TOWN OF SANDWICH, MASSACHUSETTS
SANDWICH BOARDWALK RECONSTRUCTION 2022

ADDENDUM NO. 3

October 27, 2022

SHEET NO.
C-302

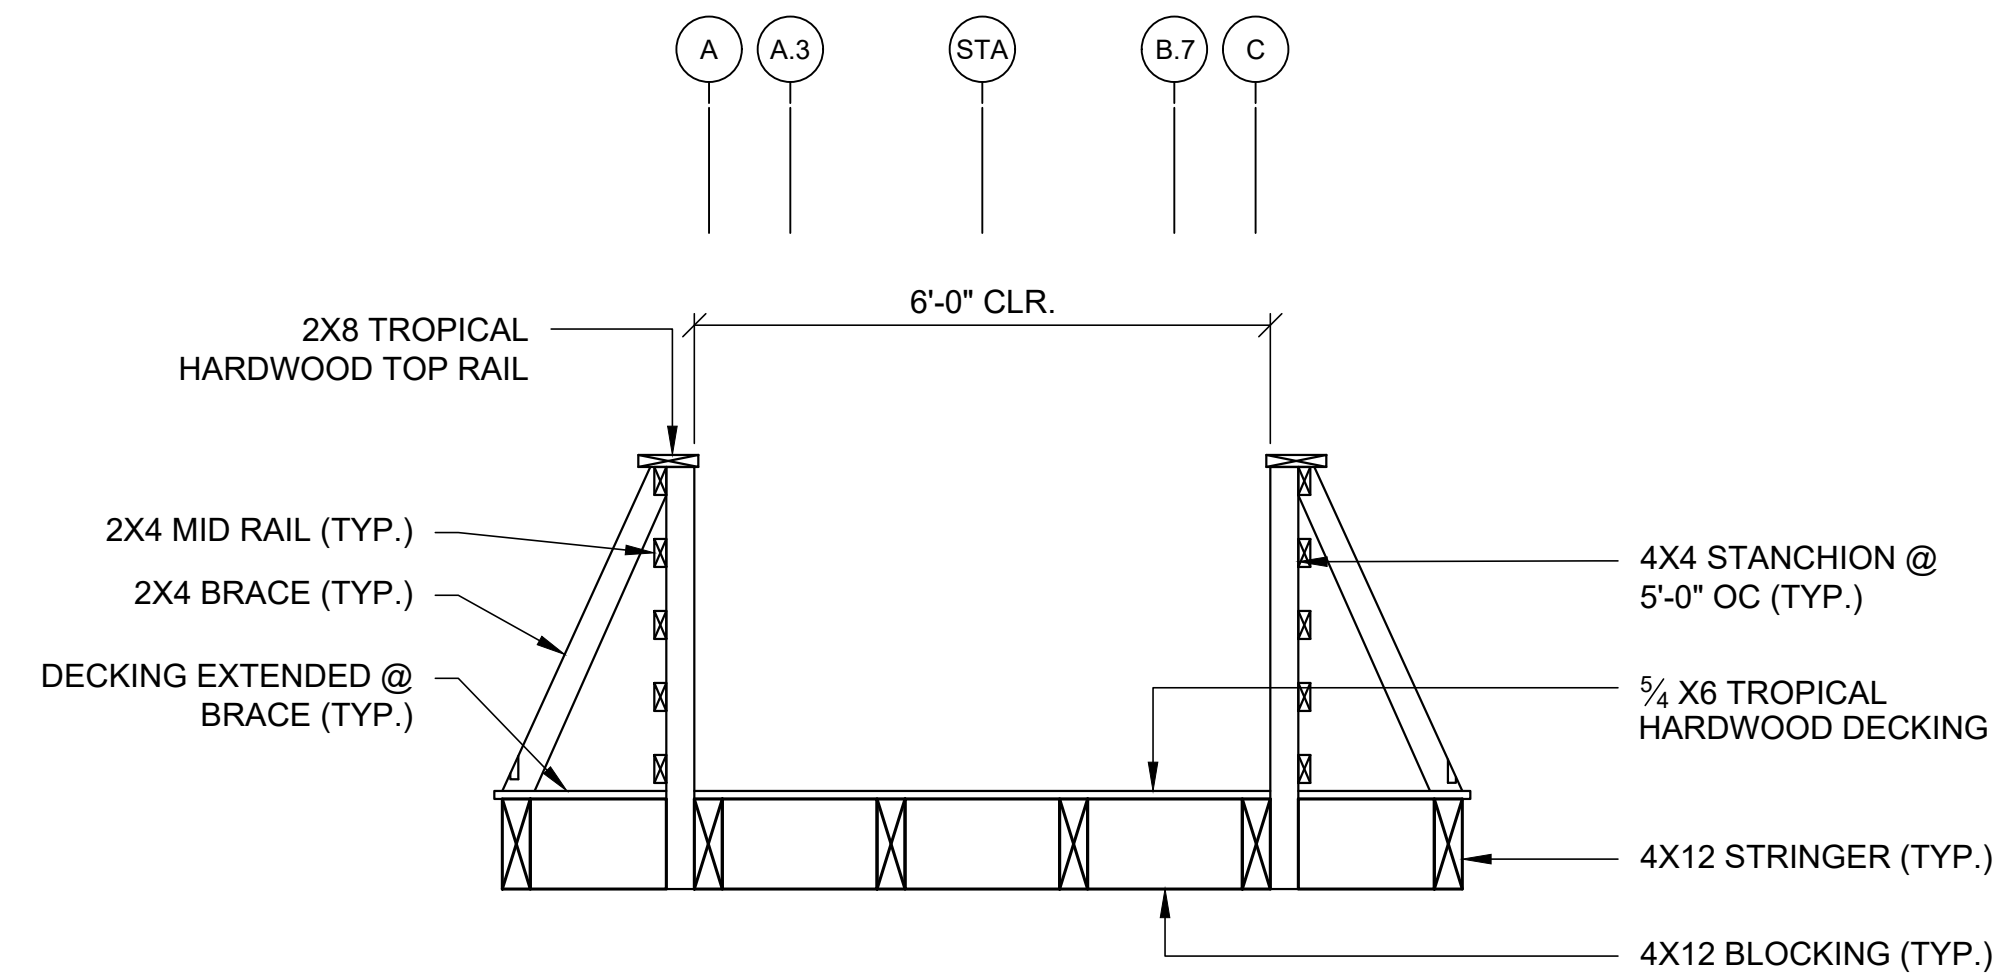
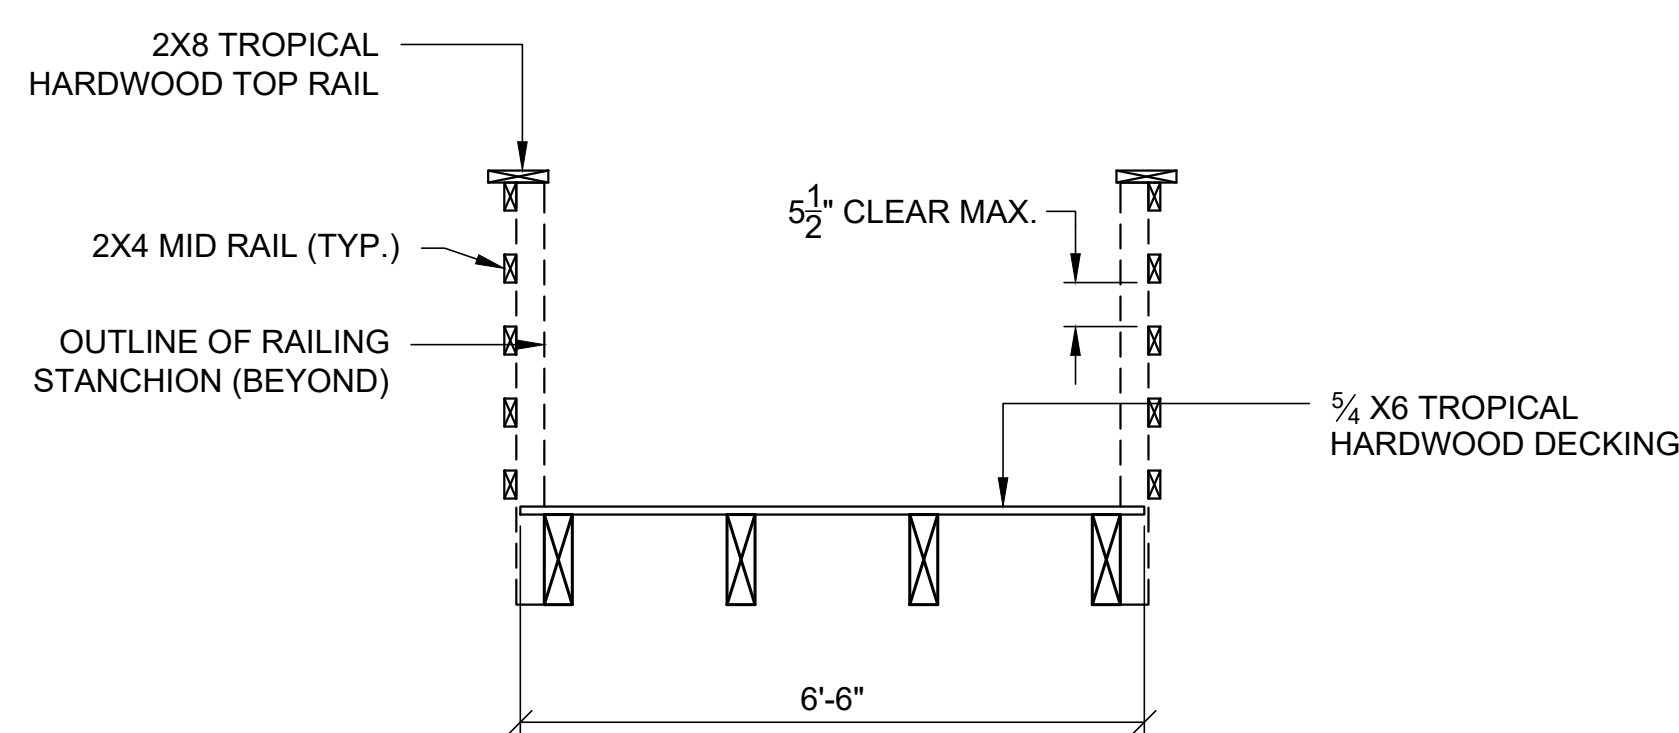
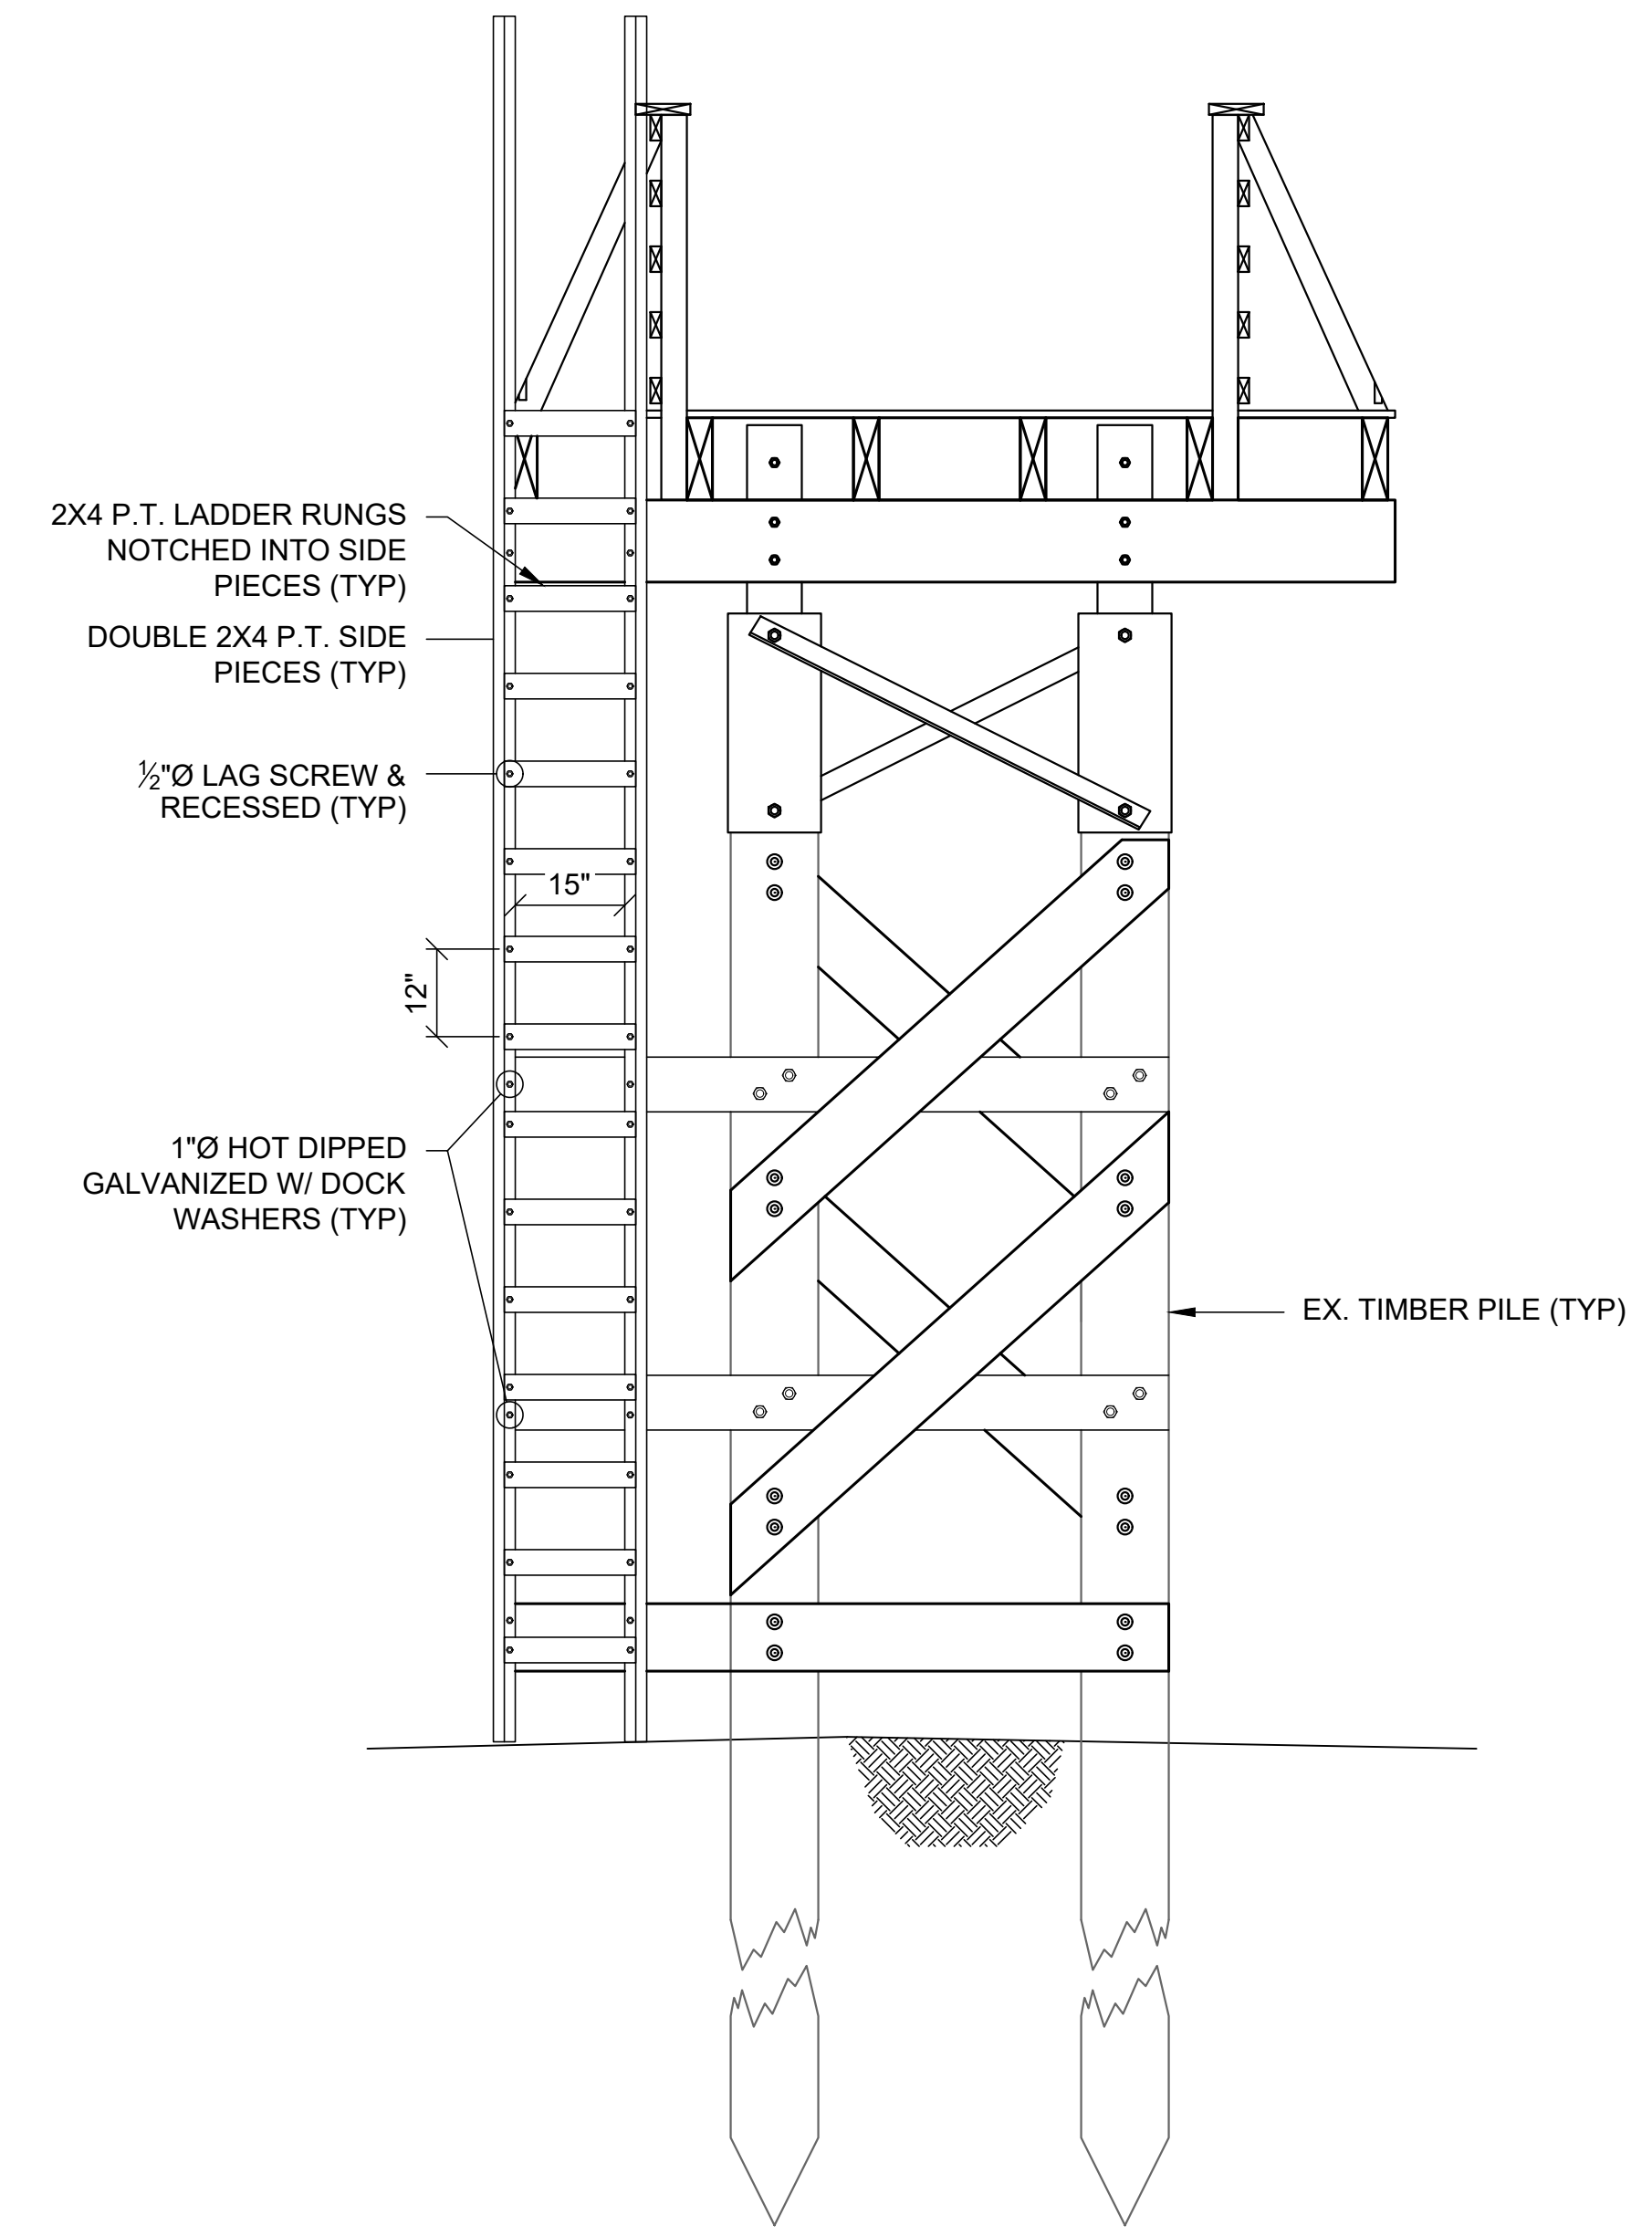
3. Regarding the Boardwalk over Mill Creek – please clarify the 4x12 stringer to 2x12 spilt pile cap connection.

Delete: Drawing C-302

Replace with: Attached Drawing C-302 Revision 1

For the connection for the Boardwalk over Mill Creek, refer to detail C/S-501 as the connection detail of spilt pile cap to the stringer. Split Pile Cap shall be 4x12 see Item No.5
